Modification Recommended Service Note

E36155A 800W Autoranging Benchtop Power Supply, 60V, 40A

Serial Numbers: MY62101001 - MY63001332

The Problem – ATTENTION – Firmware update to 1.1.15-1.0.1-1.21 and newer is mandatory.

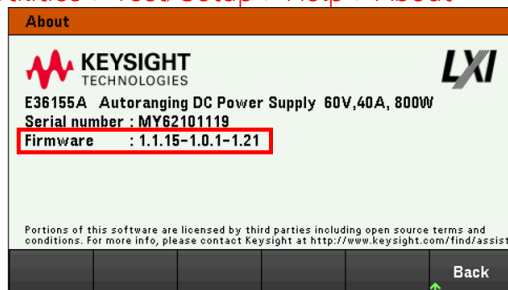
Instrument with the firmware version **1.1.10_1.0.1_1.16 and older**, may encounter failure during operation.

- Dashes "---"
- Error 614: Invalid serial number
- Error 561: Analog board (CH1) does not respond

Firmware update to **1.1.15-1.0.1-1.21** and newer is mandatory.

This firmware version resolve the booting issue when used in application with high capacitive loading.
